Date: April 28th, 2021 Project File No.: US2021-002

Attention: Port Lavaca, TX Project Name: Port Lavaca Skatepark

The following is a summary of the feedback gathered from the kick-off meeting on Wednesday, April 28th and the after meeting online survey open until May 13th. The workshop was held virtually using Zoom Webinar where the city, SPA and New Line Skateparks presented project background and three potential design directions. These directions are used to gather. Please review and contact NLS with any questions or comments.

Option 1 – "Dockside":

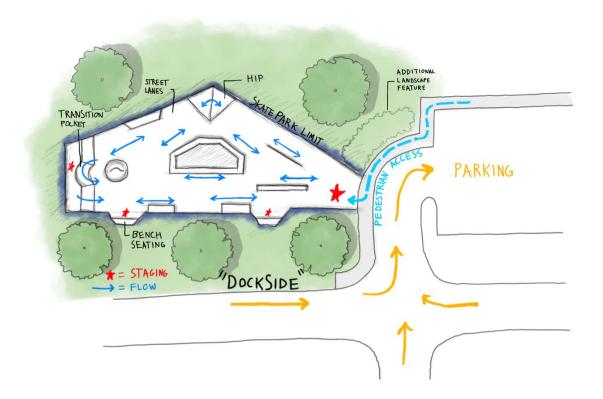
- Transition pocket.
- Single **hip**, nice ledges.
- Classic skatepark feel, good flow.
- Larger footprint.
- Open area, with variety of features.
- Simple and spacious.

- Center piece takes up space.
- No mini-ramp.
- Lots of **pushing** required.
- No gap or stairs.
- Close to parking lot.
- Needs **shade** by seating.
- Could have more transition.

Option 2 - "Pier":

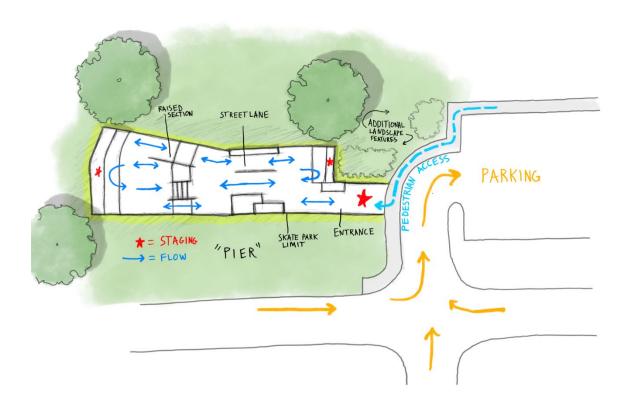
- Raised area for stairs.
- Enough space to **skate fast**.
- **Stacked** manual pad / ledge.
- Flow is **constant**.
- Range of terrain for beginner and advanced skaters.

- Narrow.
- Try to find room for a pyramid or mini-ramp.
- Only back and fourth flow.
- Crowded.

Option 3 – "Sailboat"

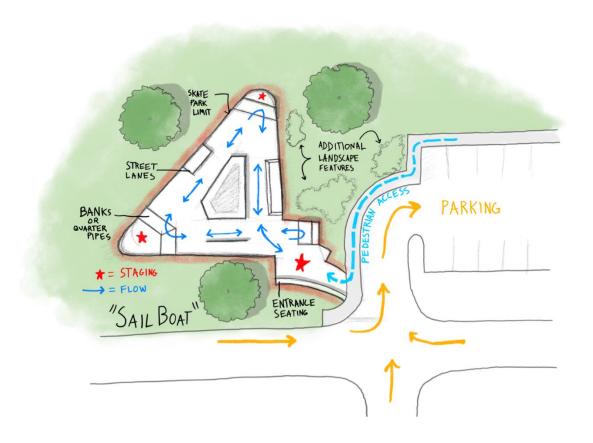
- Circular flow.
- Manual pad, ledge and rail.
- More transition in a smaller space, makes speed.
- Banks and Quarterpipes.
- Good park for **beginners**.

- Too small and crowded.
- No mini-ramp, banks or drops.
- Crowded.
- Basic.
